Alaska Department of Fish and Game

109-42-10010-2002

CORRECTION

Figure 1.-109-42-10010-2002 route correction map.

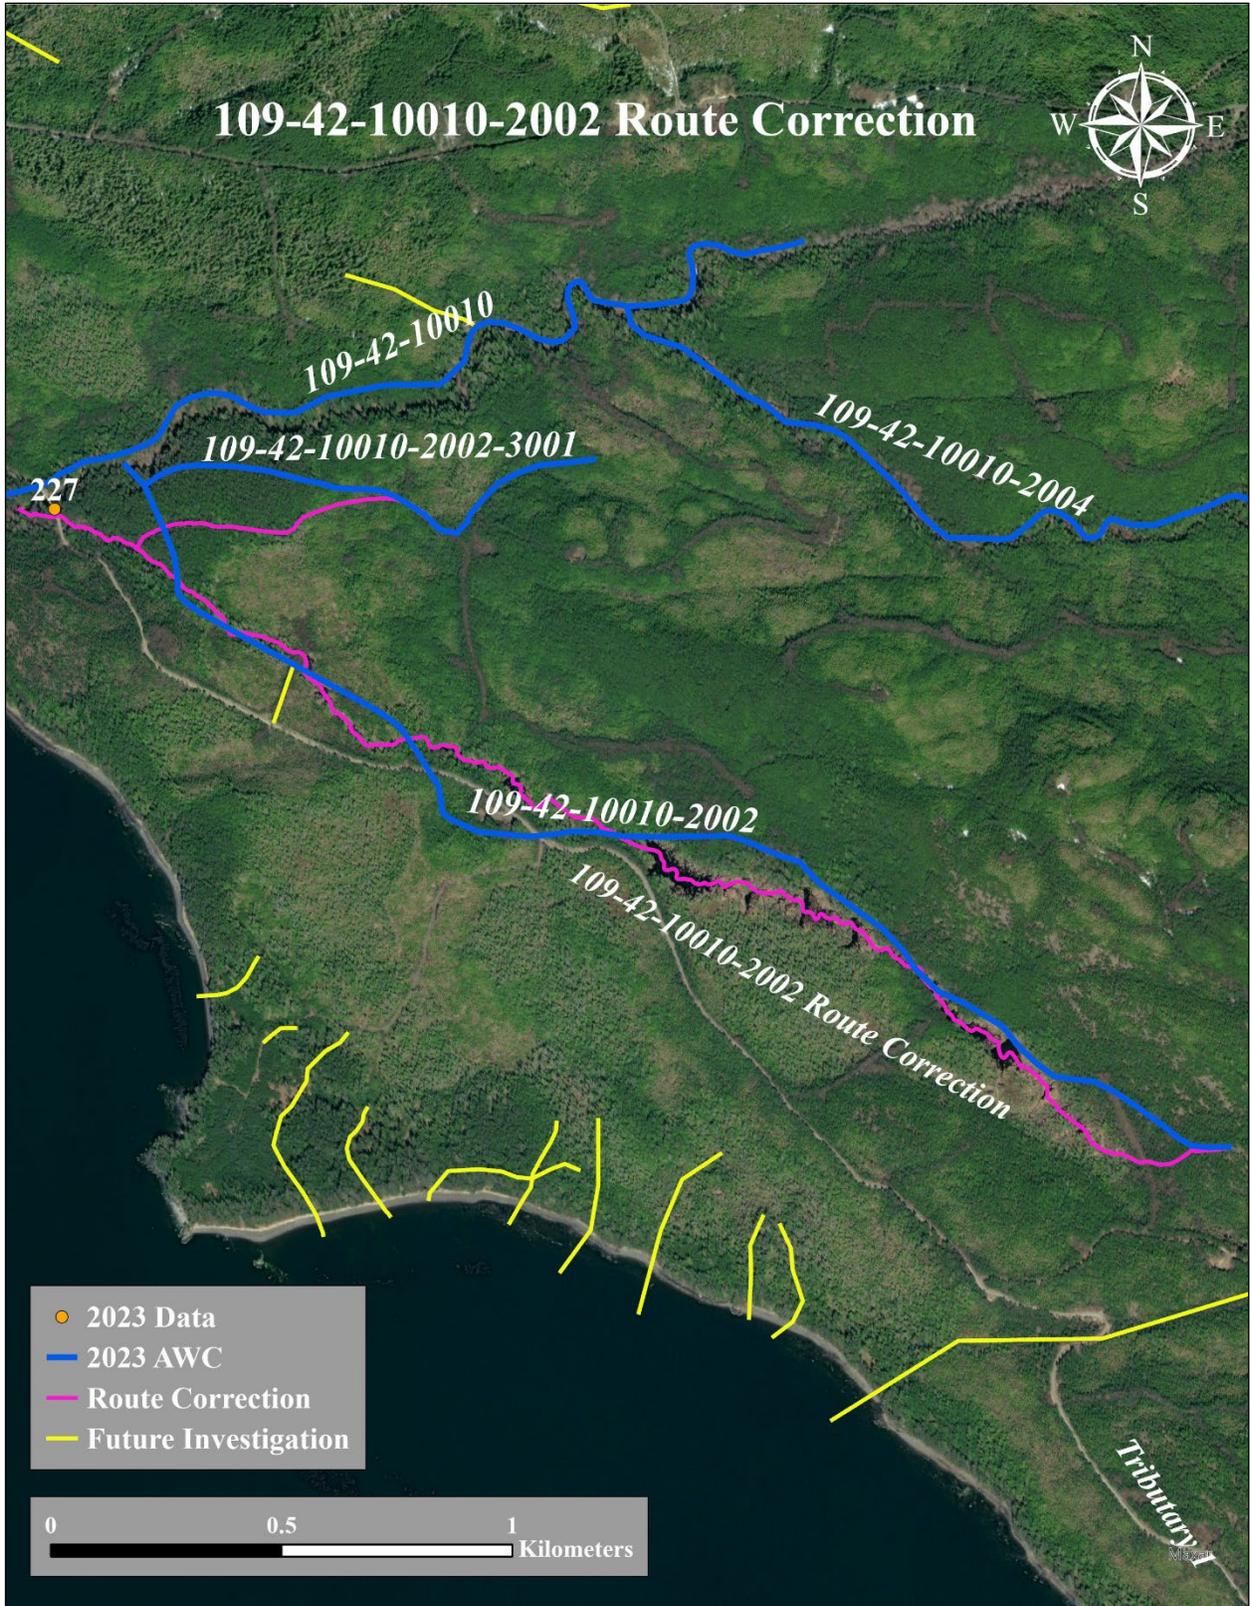
Findings: We surveyed the road crossing of this cataloged stream using a GPS and found that the stream path is incorrectly mapped. We recommend correcting the route of the stream to reflect the route identified by a LiDAR model of streams around Kake and our field survey (Table 1; Figure 1).

Waypoint	Latitude	Longitude	Notes	Stream Width ft	Stream Substrate	Habitat Features	Gradient %	Sample Effort	Sample Results
227	57.017250	-134.015509	May want to correct route of tributary to follow LiDAR/imagery.

Recommendations: Correct Stream No. 109-42-10010-2002 in the anadromous waters catalog to reflect the field verified stream path (Figure 1).
